Addendum No. 2
March 15, 2021

Project: Jane Addams Elelmentary School – C.I.P. Addition And Renovations PD #3312
Project location: 2511 W. Brookings Street, Sioux Falls, SD 57104
Project number: 1105.2914.20

Architect: Architecture Incorporated

17) DRAWING SHEET 8.30 UNDERFLOOR/TUNNEL PLAN – AREA B – PLUMBING & HEATING

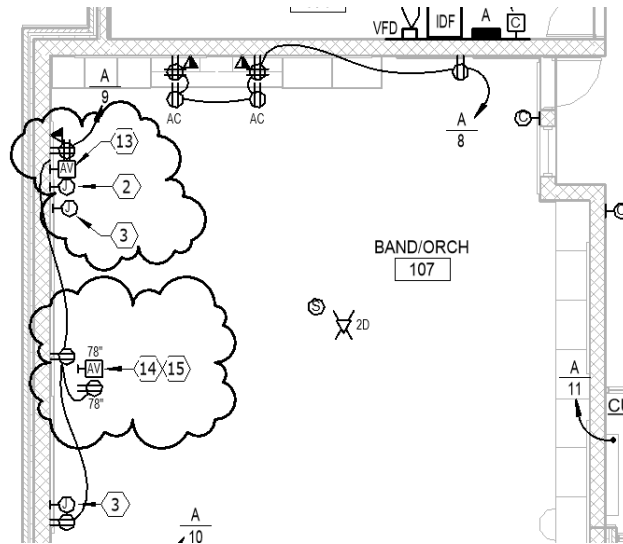
- a) Modify HWS & HWR piping as shown. Refer to revised drawing sheet 8.30, dated 3-15-21.

20. DRAWING SHEET 9.20 - SITE/ORIENTATION PLAN – ELECTRICAL

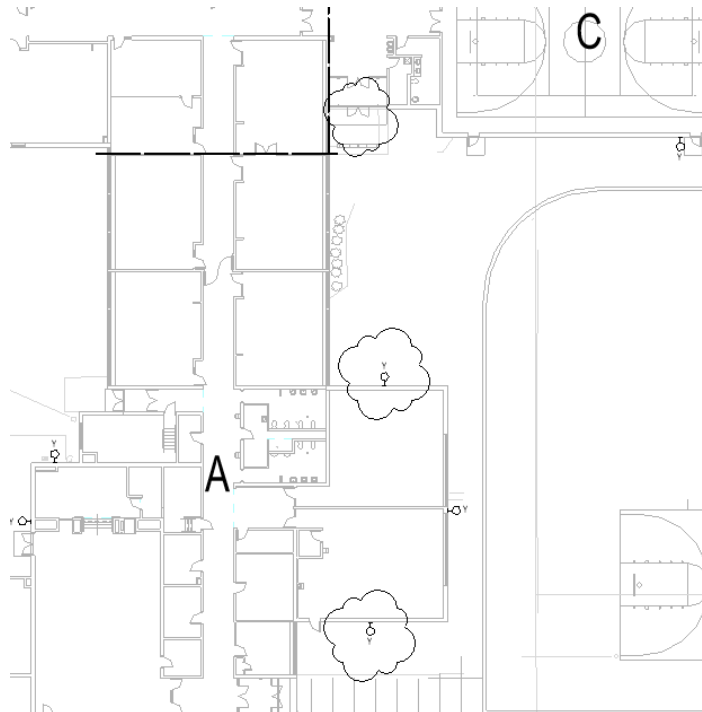
1. Provide (1) additional type “Y” fixture to replace existing wall fixture. See below for revised locations.

1 FOOTING AND FOUNDATION PLAN AREA B
3.11 1/8" = 1'-0"

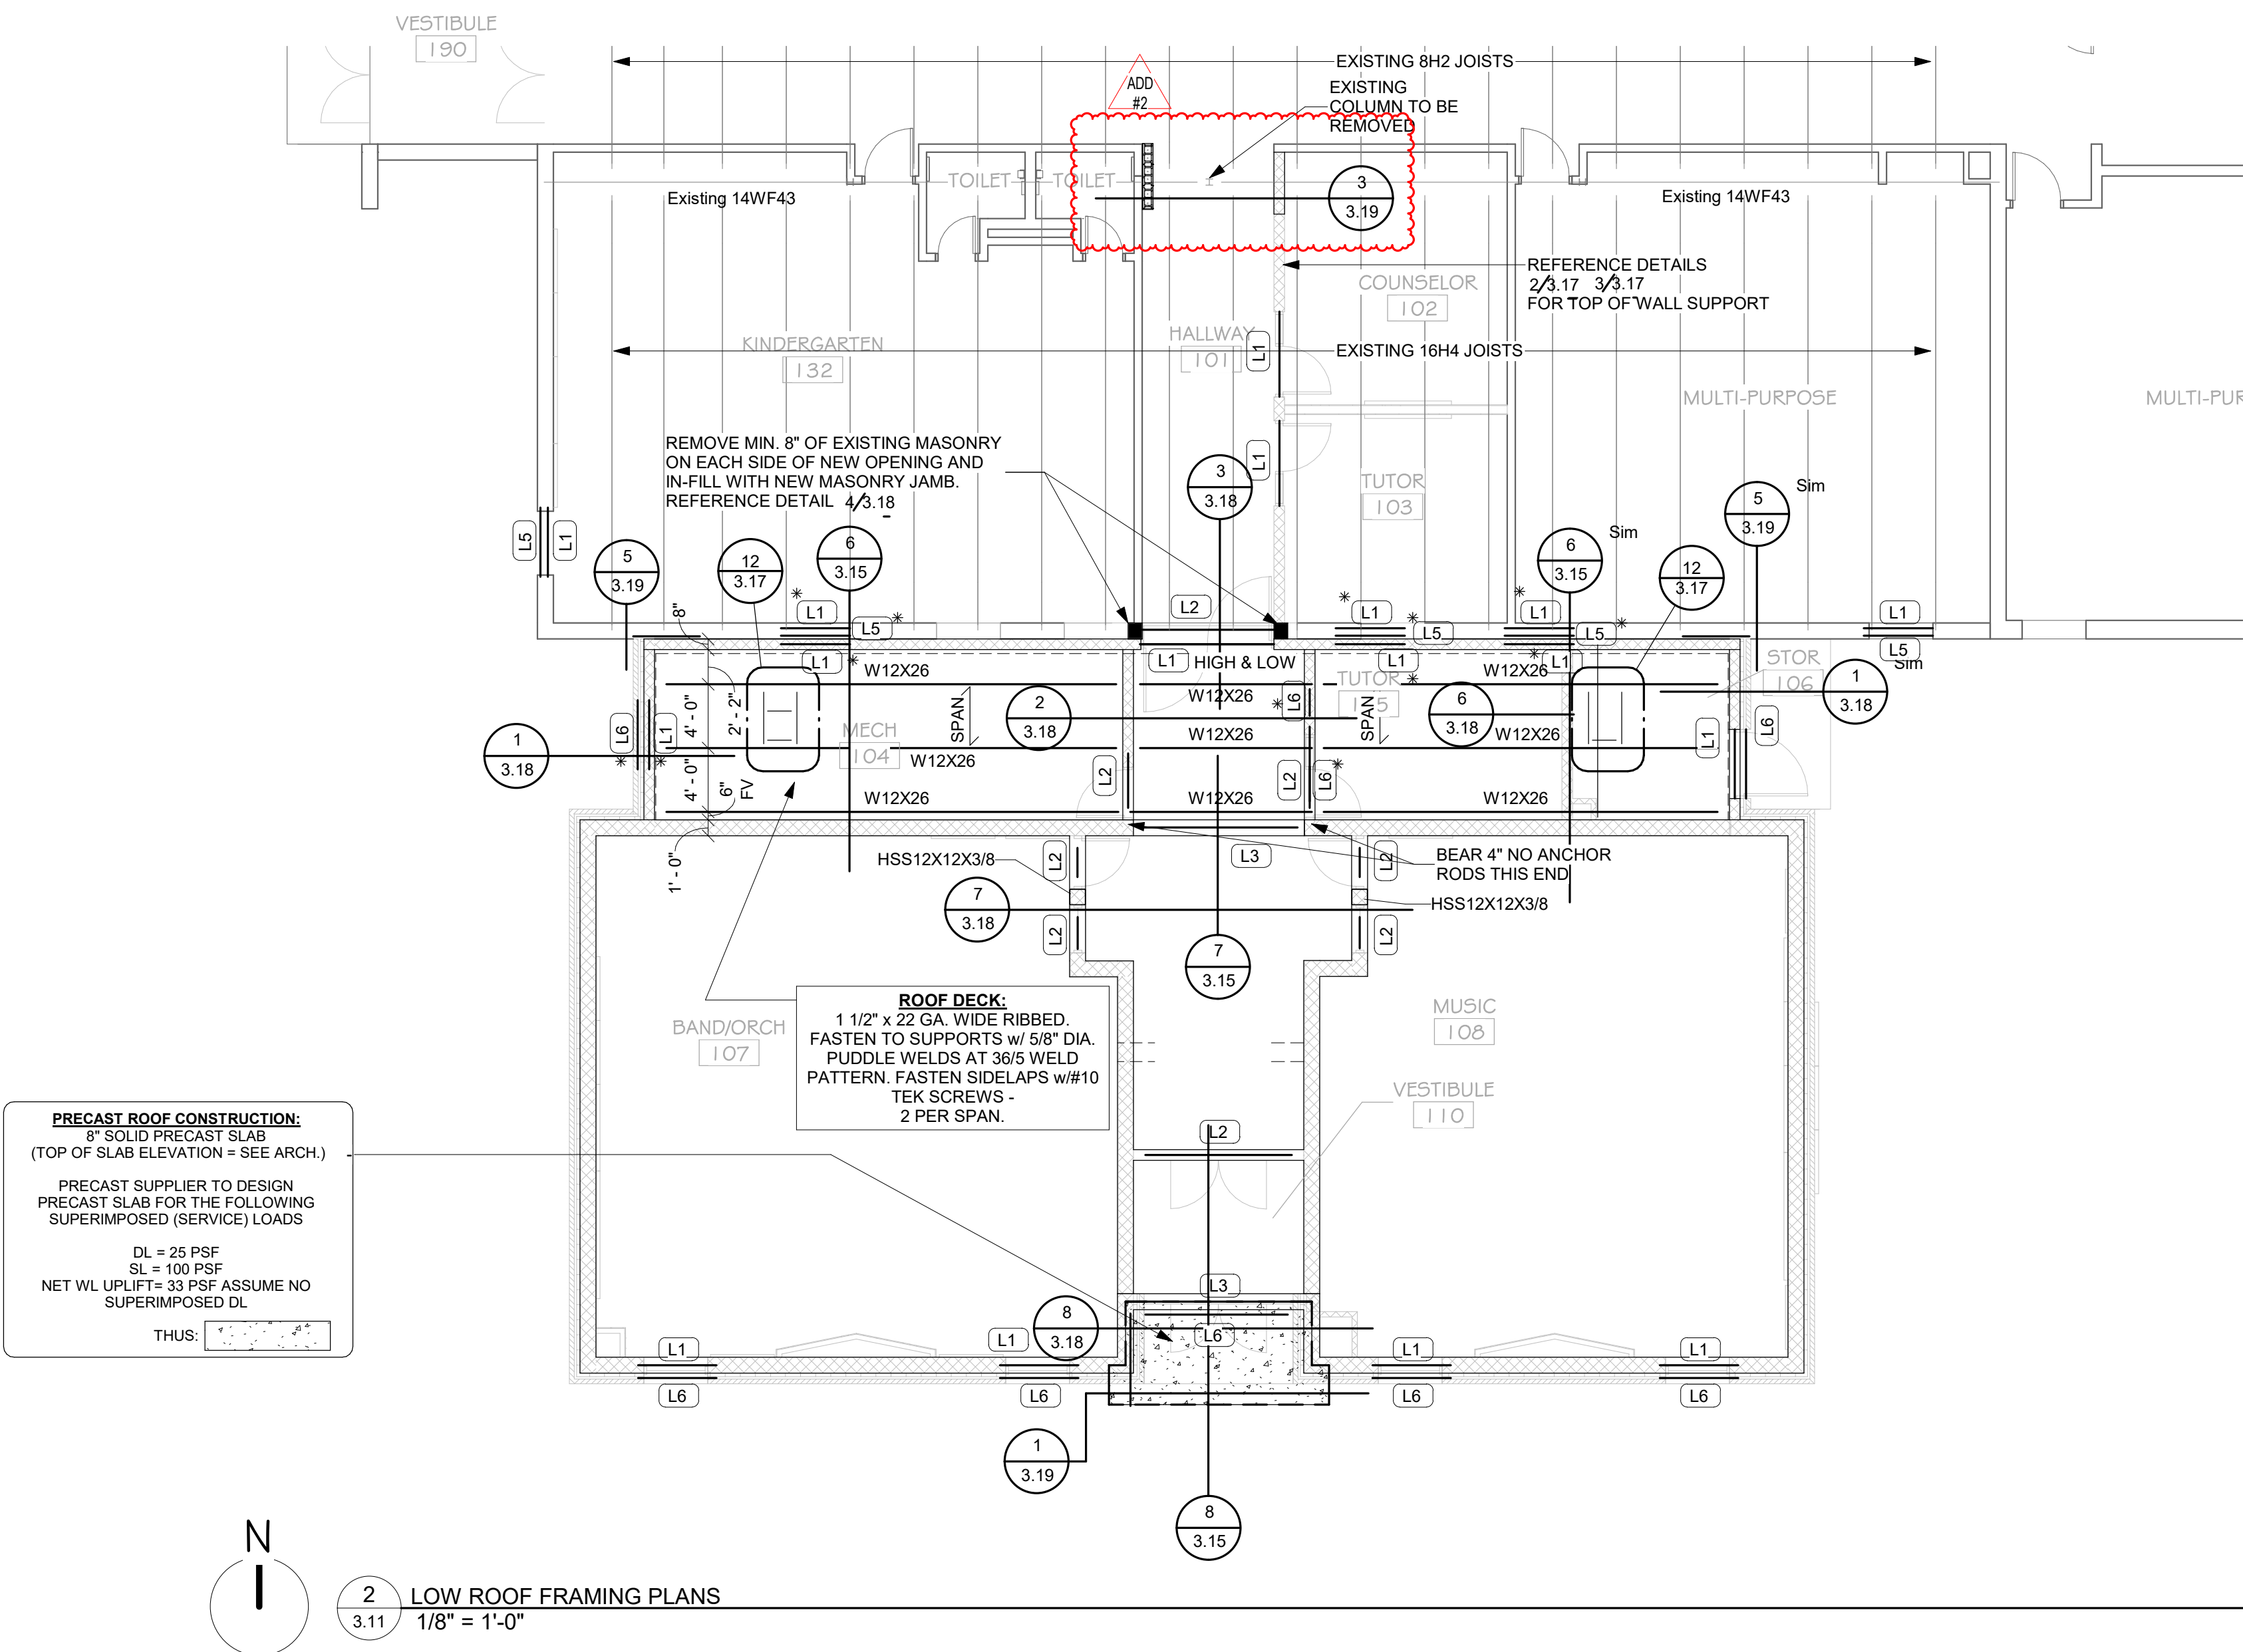
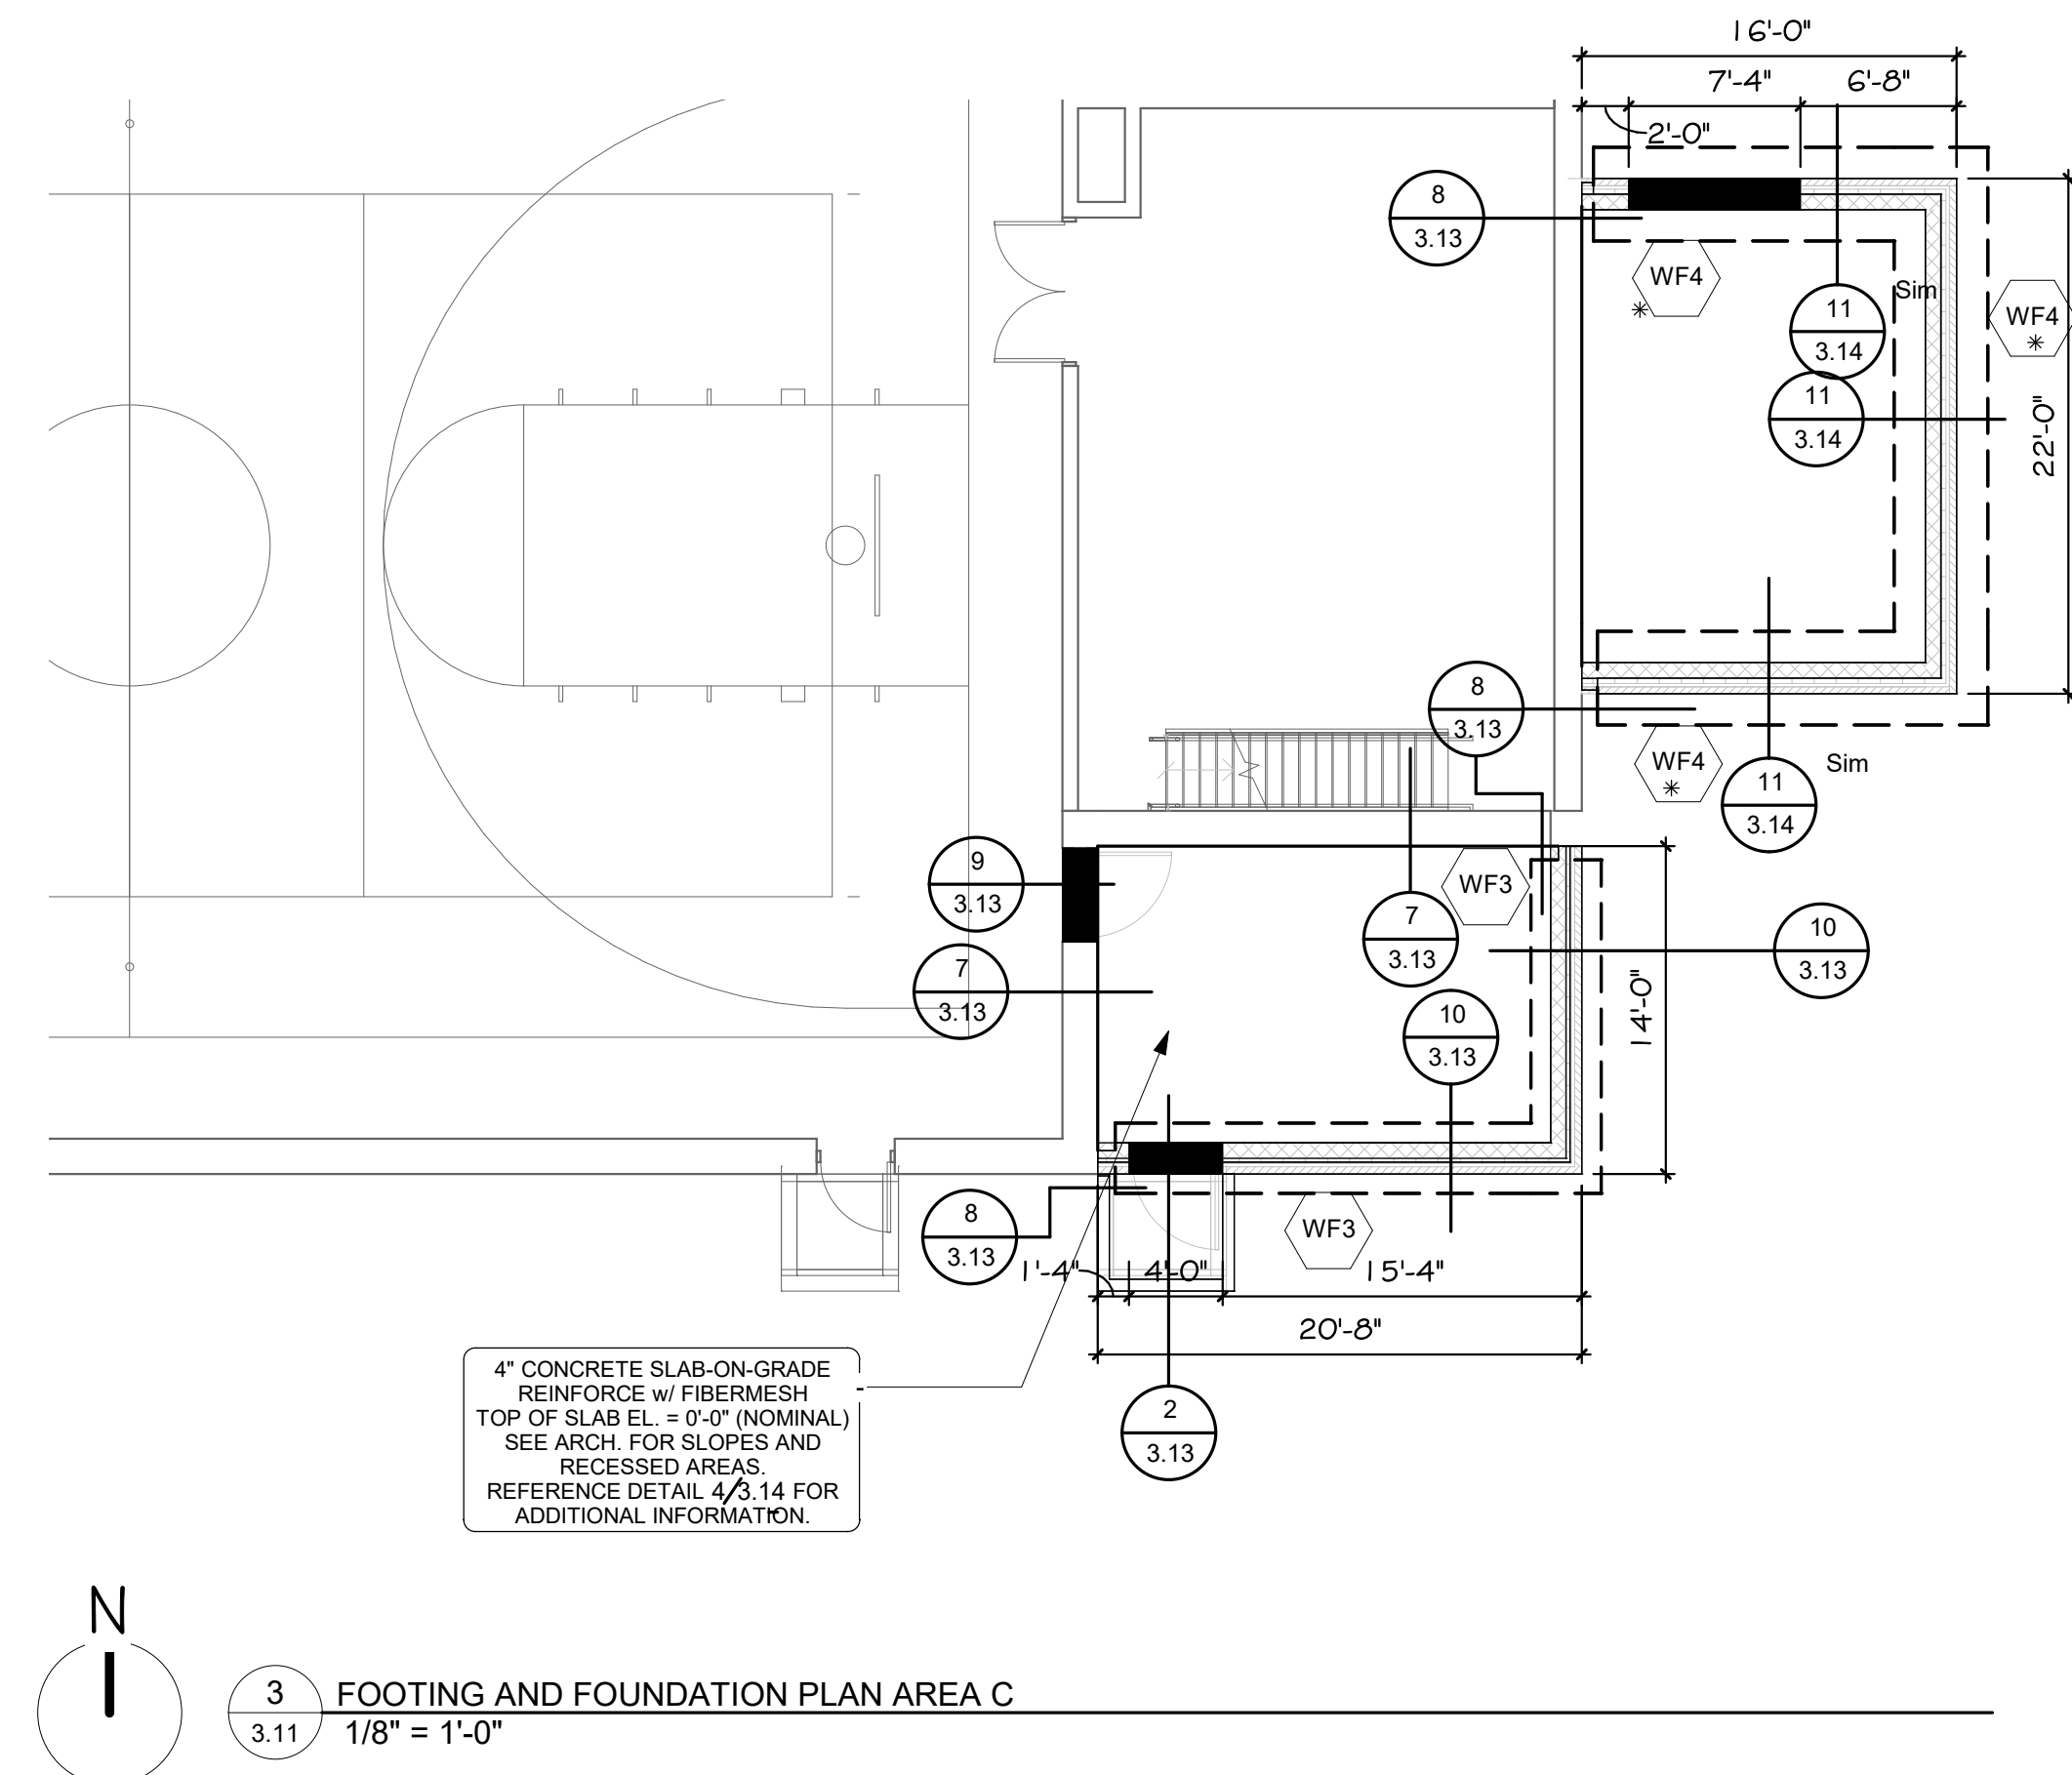
- a) Revise F4 footings and add new 32" wide x 24" deep grade beam foundation to support the new block wall along the existing corridor wall shown in plan views 1/3.11 and 2/3.11.
